PLANS AND DOCUMENTS
referred to in the PDA
DEVELOPMENT APPROVAL
Approval no: DEV2020/1150/5
Date: 30-Nov-2022

FLIPSIDE CIRCUS NORTHSORE

AMENDED 9 NOVEMBER 2022
TO REFLECT STAGING AND
AS-CONSTRUCTED UPDATES

1 SITE PLAN
1:250

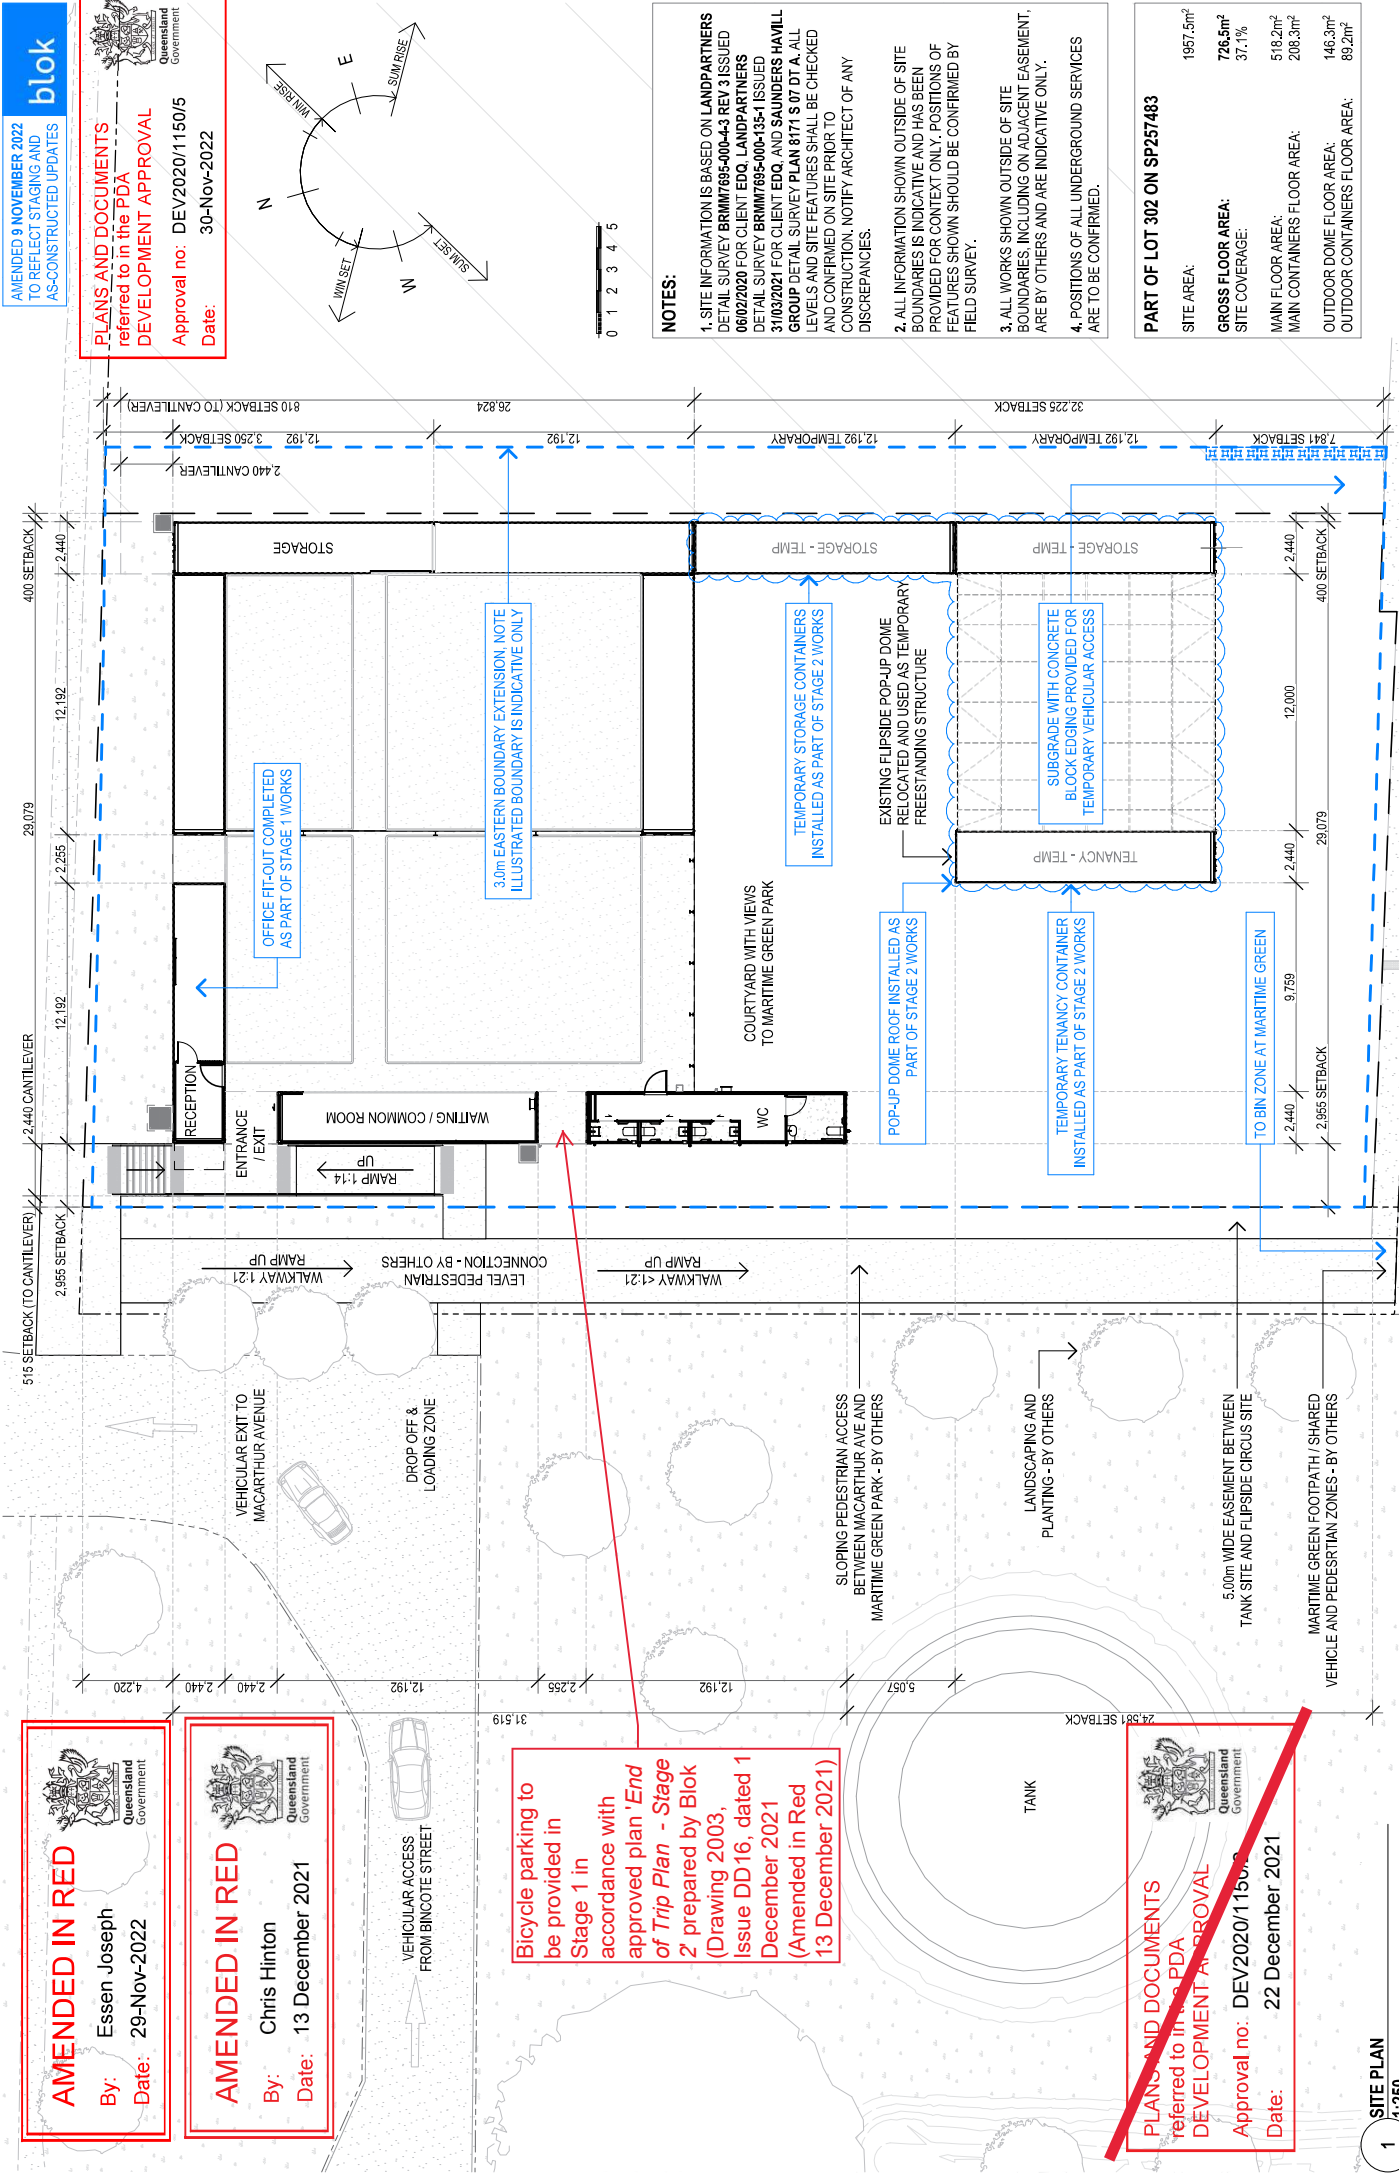
Bicycle parking to be provided in Stage 1 in accordance with approved plan 'End of Trip Plan - Stage 2' prepared by Blok (Drawing 2003, Issue DD-16, dated 1 December 2021 (Amended in Red 13 December 2021))

Future Landscape works subject to Compliance Assessment under Condition 30

1 OVERHEAD POWER LINES PLAN 1:150

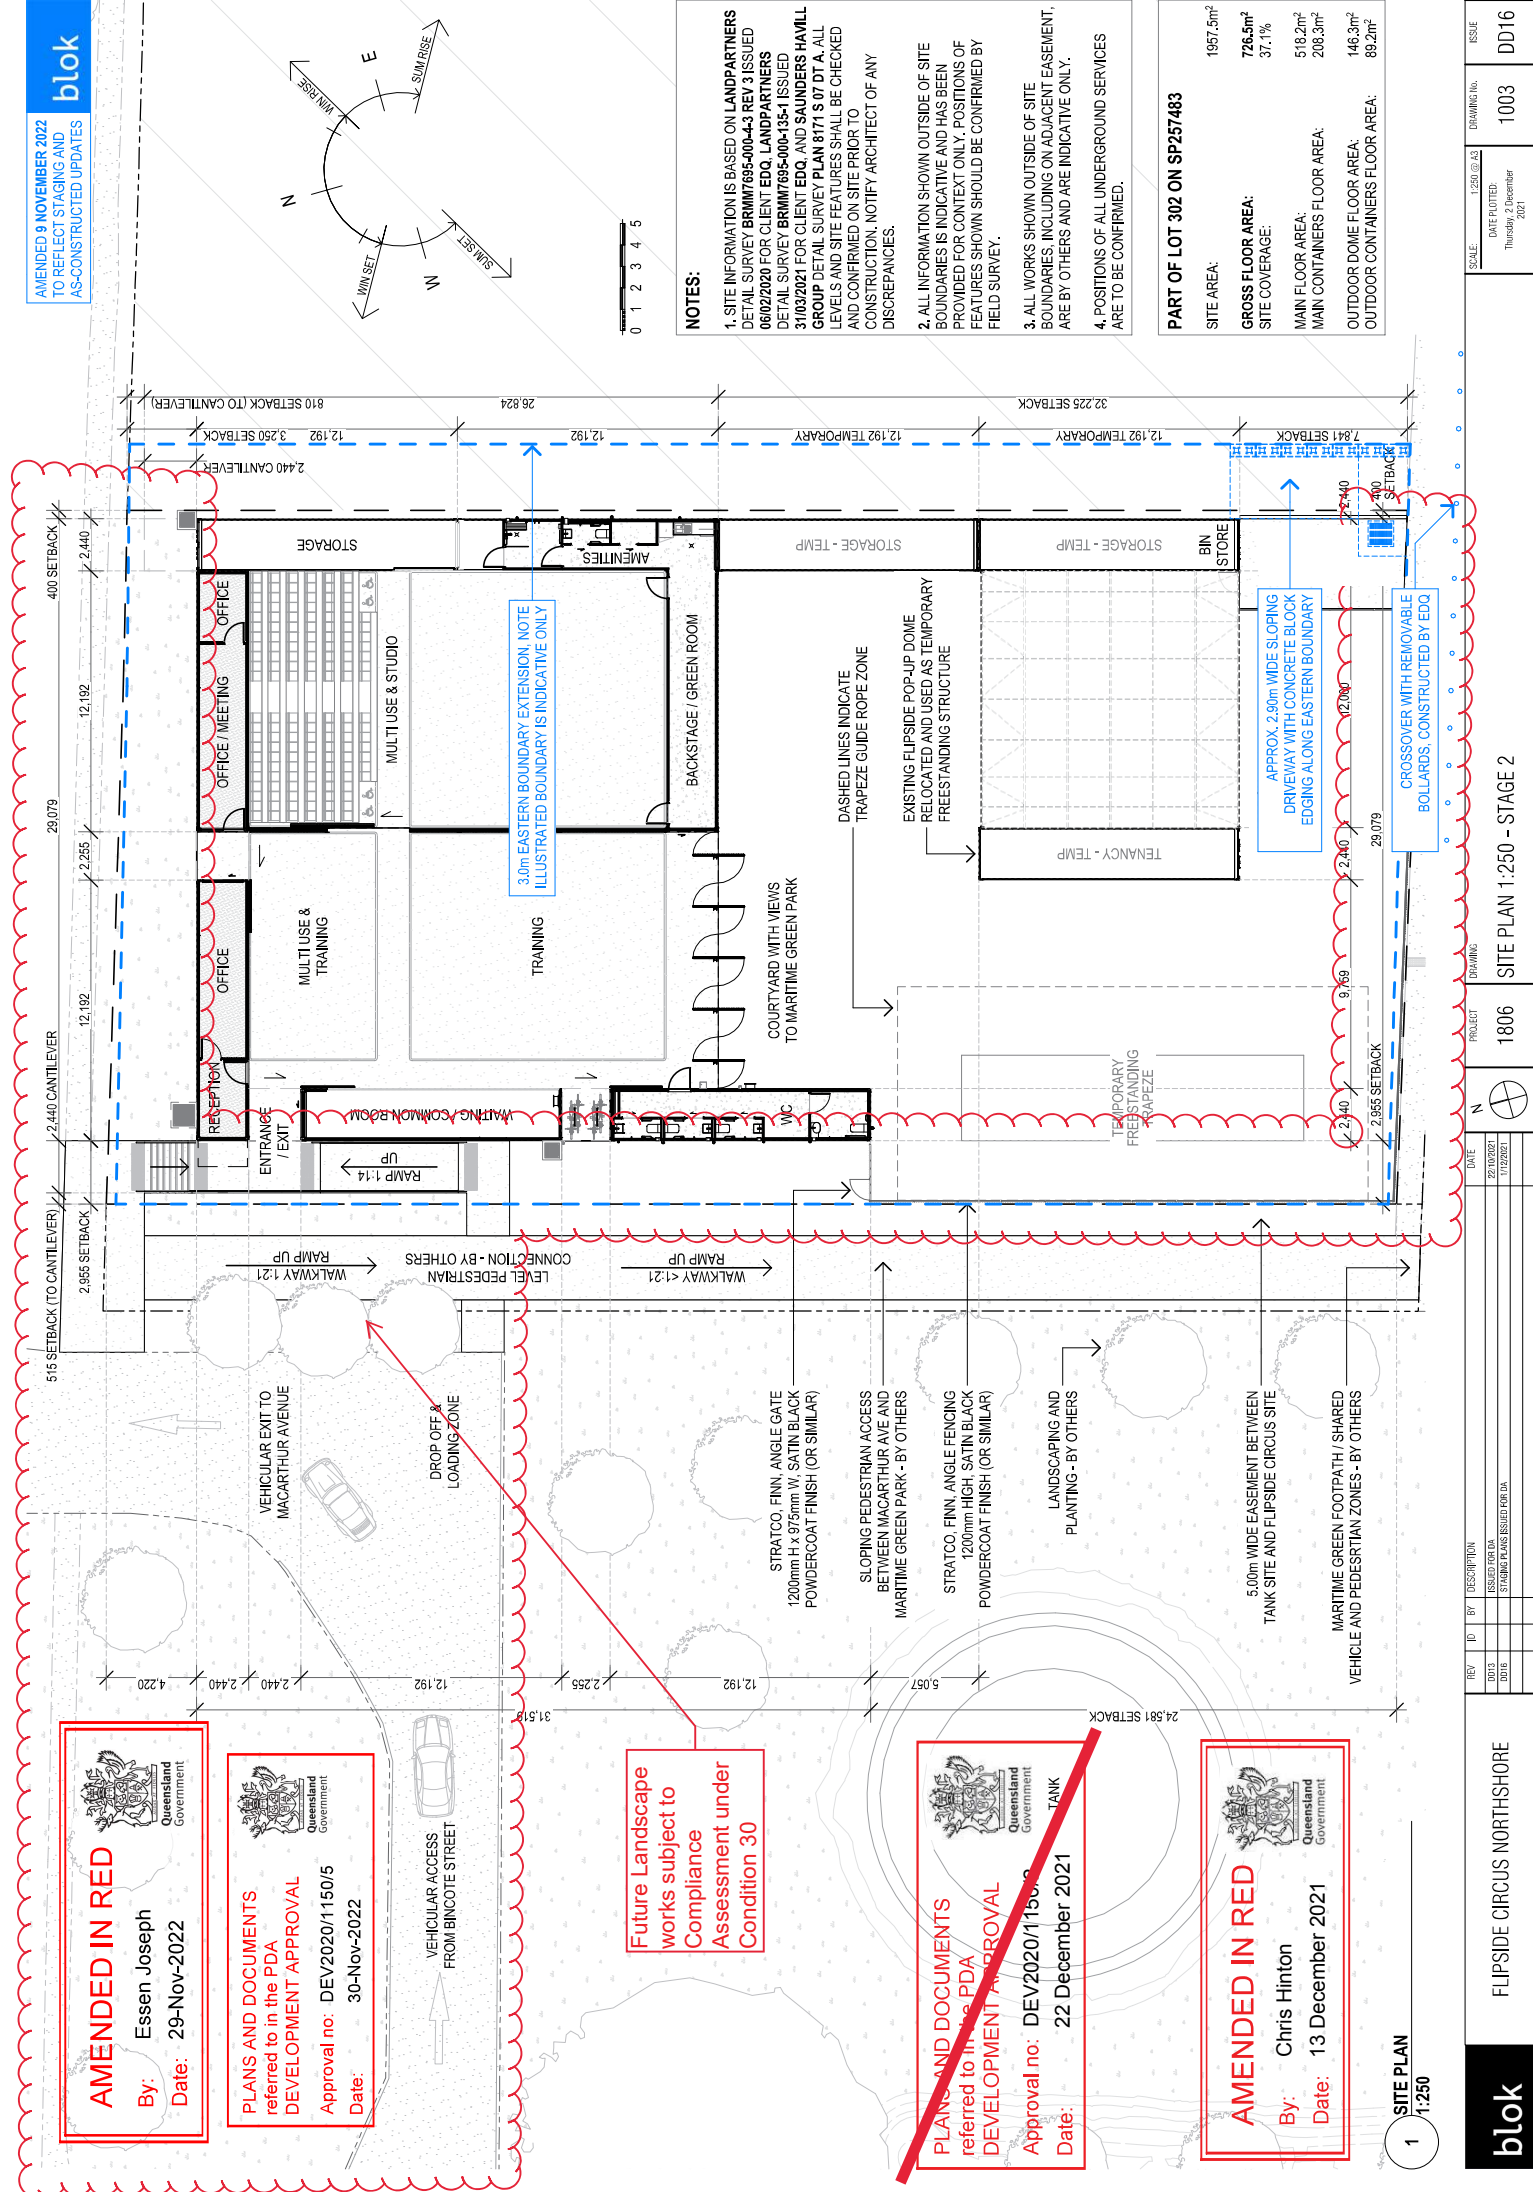
Future Activation
and Passive
Surveillance works
subject to
Compliance
Assessment under
Condition 31.

1
GROUND FLOOR PLAN
1:150

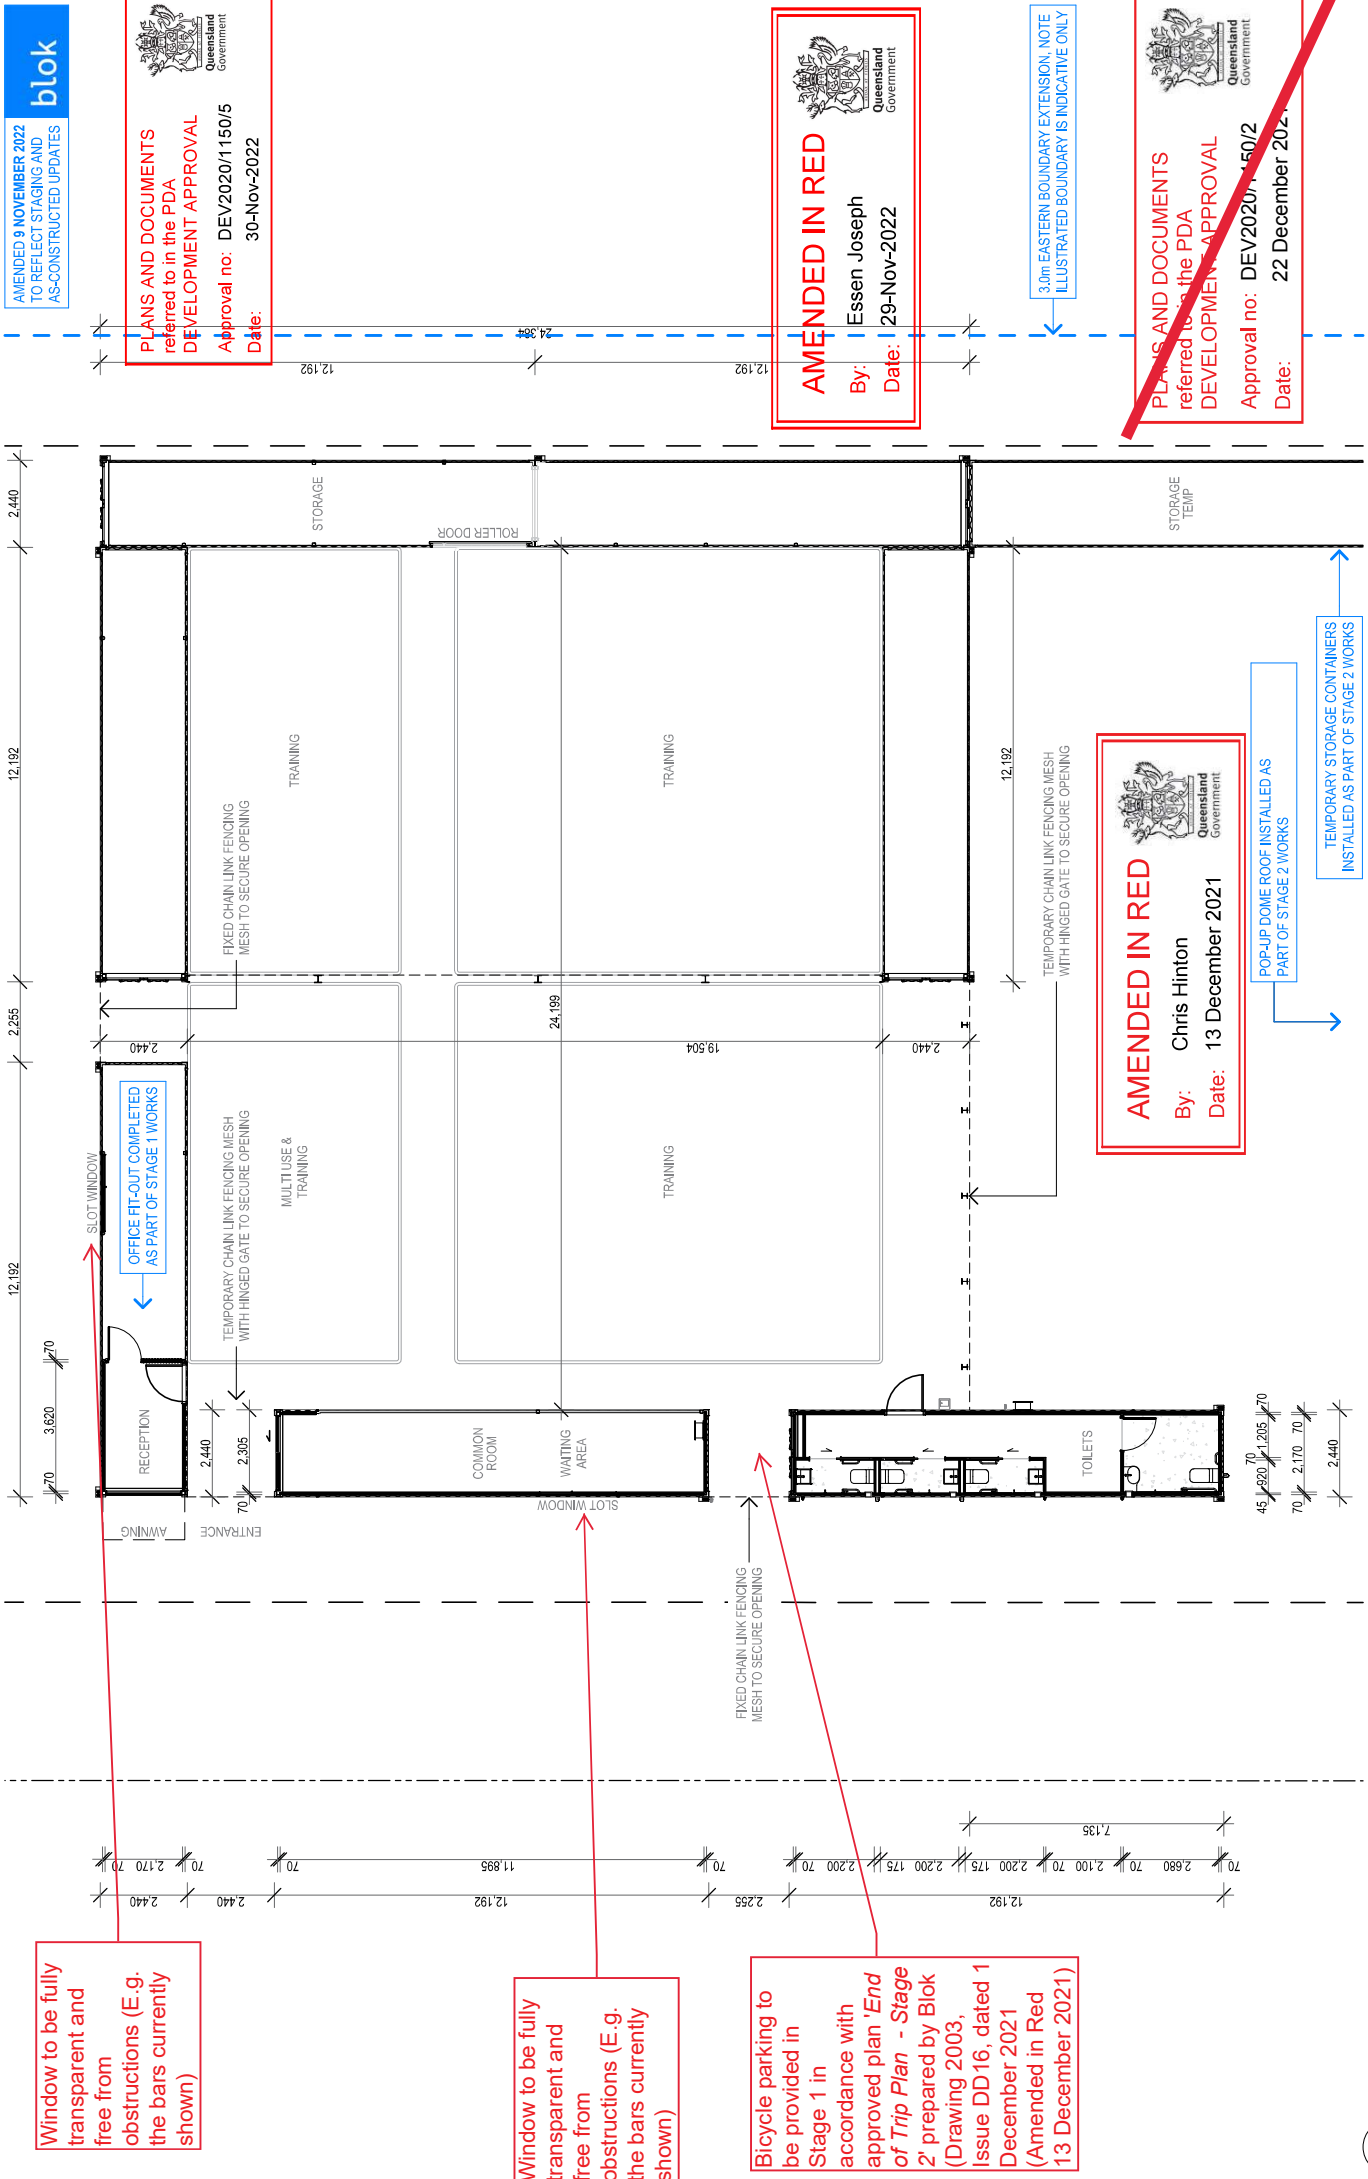
Window to be fully transparent and free from obstructions (E.g. the bars currently shown)

Window to be fully transparent and free from obstructions (E.g. the bars currently shown)

Both windows to be fully transparent and free from obstructions (E.g. the bars currently shown)
